SUBJECT: Brunswick Steam Electric Plant, Unit No. 2
Docket No. 50-325/License No. DPR-62
Revision of Request For License Amendment -
Frequency of Performance-Based Leakage Rate Testing
(NRC TAC No. MB3471)

1. Marked-up Technical Specification Pages - Unit 2
2. Typed Technical Specification Pages - Unit 2
3. Engineering Change 49741, Revision 0, "Evaluation of Risk from Containment Liner Change"

Engineering Change 49741, Revision 0,
"Evaluation of Risk from Containment Liner Change"

ATTACHMENT 2
Sheet 1 of 1
Record of Lead Review

SURFACE AREAS

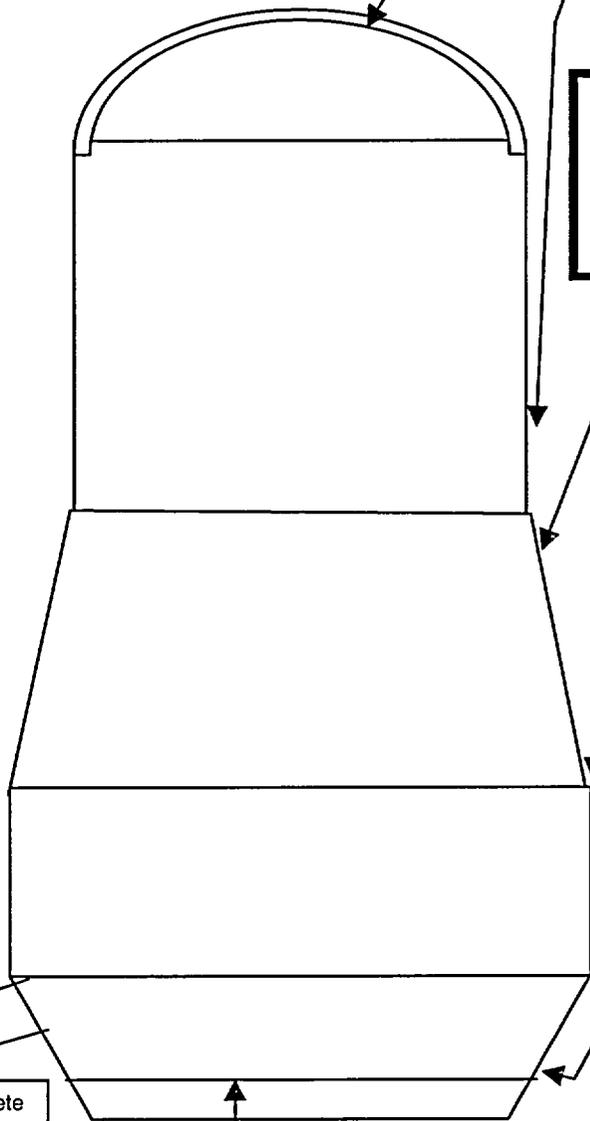
Eric V. Browne	PSA	
Lead Reviewer	(print/sign)	Discipline
		Date
Item No.	Deficiency	Resolution
1)	Diagram - The torus dry area listed in the diagram is not correct. It appears to be a typo and the area should be shown as 18,282 sq ft instead of 8,282 sq ft	Correction made.

2)	Diagram - The units listed for surface area S6 in the diagram are not correct.	Correction made.
3)	Section D Historical Information – replace “reinforced primary containment” With “reinforced concrete primary containment”	Correction made.

4)	Diagram – The area of section S8 appears to be slightly off (2361 vs. 2376) Similarly, the total area for the vent lines is slightly off (3820 vs. 3816) The difference in the estimated area S9 is due to rounding prior to multiplying by the number of lines, but the reason for the difference in the estimated area S8 is undetermined. Correct as needed.	S8 corrected to 2369 sq ft to reflect consistent use of radii of 27' 5.5". Vent line area maintained at 3,816 sq ft to reflect rounding of each vent line to whole number (477 sq ft) prior to multiplying by the number of vent lines (8).

10)	The information for “Drywell Floor Surface Area (sq ft)” discrepancy was noted in comment 4 (area of S8). This also affects the total surface area. Most of the remaining data only differs due to rounding errors, but the basis for this point estimate is undetermined. The net result does not impact the answers significantly, but should be reconciled.	See resolution for comment 4.
